AMENDMENTS TO THE DRAWINGS/FIGURES

Applicant: Richard M. Lloyd
Title: VEHICLE-BORNE SYSTEM AND METHOD FOR
COUNTERING AN INCOMING THREAT
Serial No.: 10/698,500
Docket No.: RAY-144J
Attorney: Iandiorio & Teska

FIG. 4

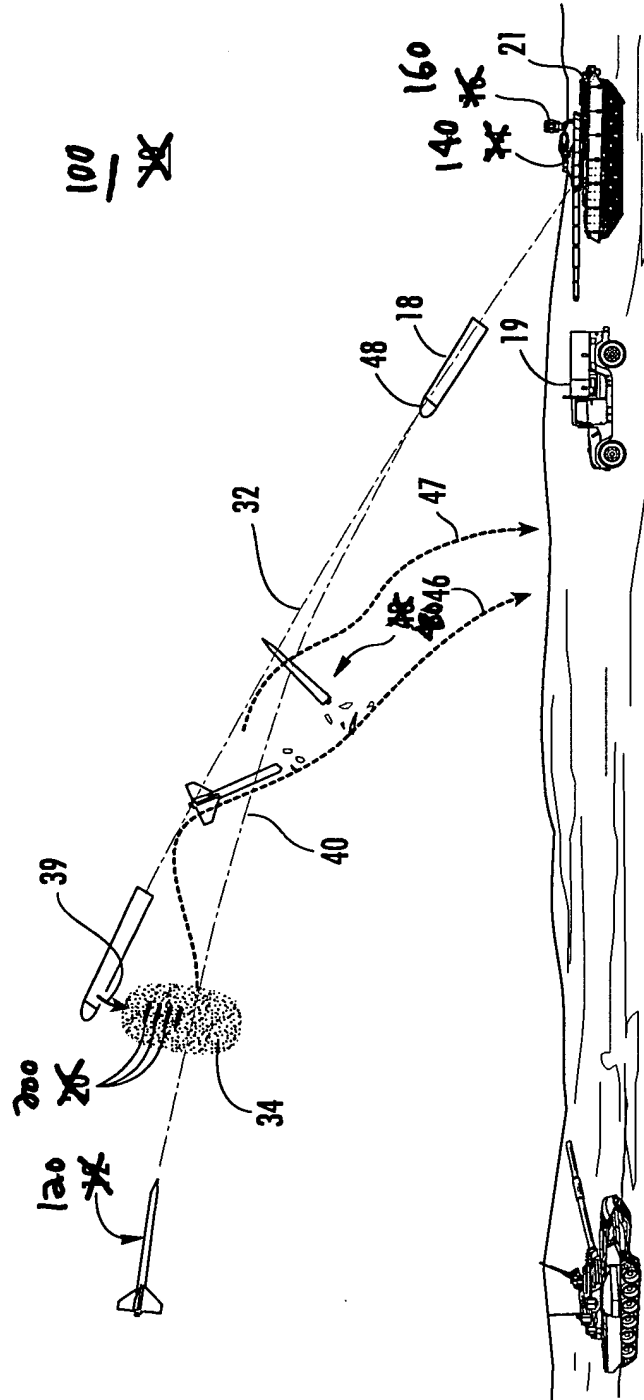
Additionally, the applicant has included proposed drawing changes corresponding to the changes in reference numeral designations in the specification. Particularly, the applicant proposes in Fig. 4 that references numerals 12, 20, 48, 14 and 16 be changed to 120, 200, 480, 140 and 160, respectively; also, in Fig. 5, that reference numeral 14 be changed to 140; in Fig. 6, that reference numeral 19 be changed to 190; in Fig. 7A, that reference numeral 16 be changed to 160; in Figs. 8A, 8B and 8C, that reference numerals 20 and 22 be changed to 200 and 220, respectively; in Fig. 8C, that reference numeral 24 be changed to 25; and in Fig. 9, that reference numerals 12, 20, and 10 be changed to 120, 200 and 100, respectively. Also in Fig. 9, the applicant proposes that reference numeral 18 be changed to 220. Additionally, the applicant proposes removal of the word "VEHICLE" in Fig. 9. Also, in Fig. 22, the applicant proposes that reference numerals 100, 102, 104, and 106 be changed to 1000, 1020, 1040, and 1060, respectively.

FIG. 22

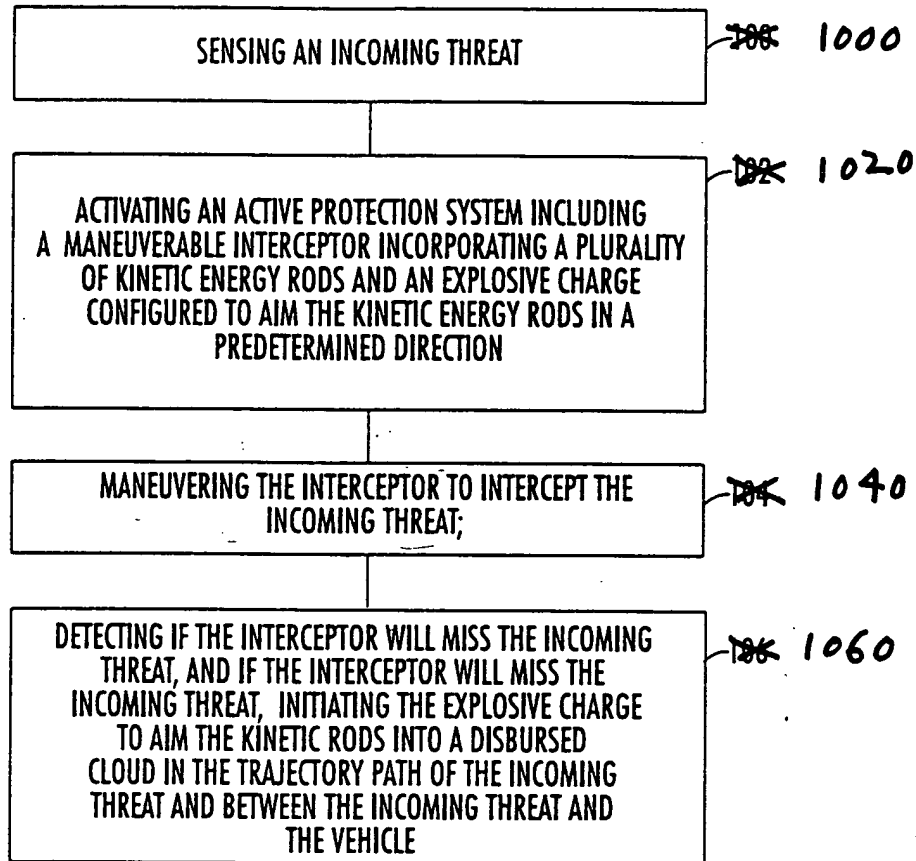
Additionally, on page 15, at line 18, the applicant proposes the addition of the words "maneuvering interceptor 18 to intercept incoming threat 120, Fig. 4, step 1040, Fig. 22". This addition is consistent with step 104 (now 1040) in the original drawings, and thus no new matter has been added.
